Access Compliance Report

Public Rights-of-Way

| Intersection ID: 50602 | Main Street: RHODORA_RD | Cross Street: CEDARFIELD_RD | Location: NE |
| ADA ID: F94B9F2D43B4 | Ramp Type: Perp | Initial Pass/Fail: Fail | Overall Compliance: No |

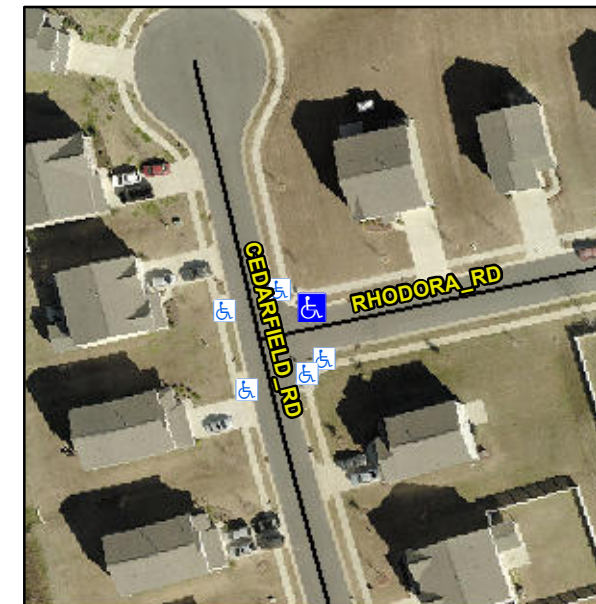
Not Found, R304.5.1, R304.2.2, R304.5.3

| Compliance | Description | Data | Compliance | Description | Data |
|------------|-----------------------|------|------------|-----------------------------|------|
| N/A | Ramp Length (in) | 50.0 | No | Ramp Slope (%) | 12.1 |
| No | Ramp Width (in) | 47.0 | No | Ramp XSlope (%) | 3.2 |

Remove & Replace Entire Ramp.
